# SERVICE INSTRUCTION

Service Instruction No. 1444  
Engineering Aspects are  
FAA Approved

TCM Ignition Systems Service Bulletin No. 630

**SUBJECT:** Revised timing procedures for eight cylinder S-1200 Series Magnetos with retard contact assembly installed.

Figure 1  
Alignment of Timing Marks  
and Rib at E-Gap

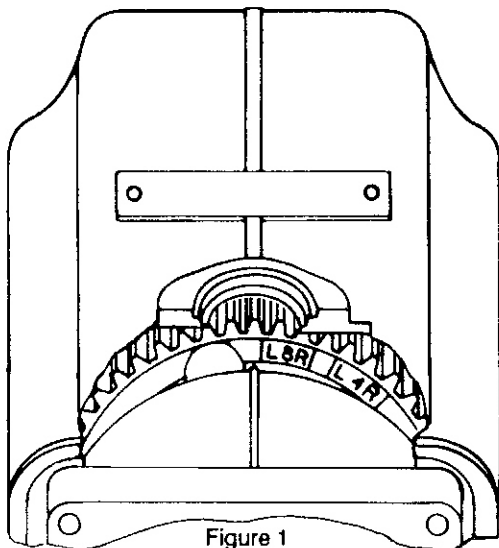
- c. Adjust cam for main contact opening at  $12^\circ \pm 1^\circ$  past neutral in normal direction of rotation (E-Gap) as specified in ASSEMBLY, paragraph 9.2.10, step D. If, after tightening screw, E-Gap is not  $12^\circ \pm 1^\circ$ , loosen screw, pry cam loose and reset E-Gap. Secure cam with new screw.

Figure 2  
Permissible Range of Timing Alignment  
at E-Gap

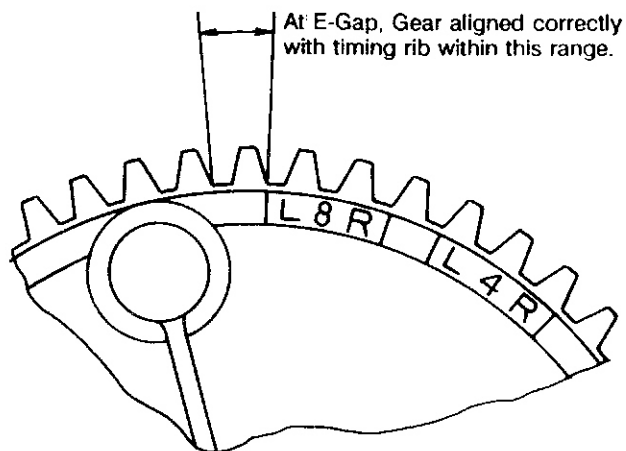
- a. With distributor block and distributor gear disassembled from magneto, set rotating magnet in E-Gap position as described in ASSEMBLY, paragraph 9.2.14, step A.
- b. Ensure L mark adjacent to numeral 8 on gear is painted with red dykem.
- c. With distributor gear assembled to distributor block, turn gear until rib on block lines up with peak of tooth which falls immediately to the left of painted mark.
- d. Holding the distributor gear and block aligned as described above, assemble the block and gear into the housing, meshing distributor and drive gears together. See Figure 1. Rib alignment with tooth peak shown in Figure 2 is preferable, however, rib alignment with valley is permissible.
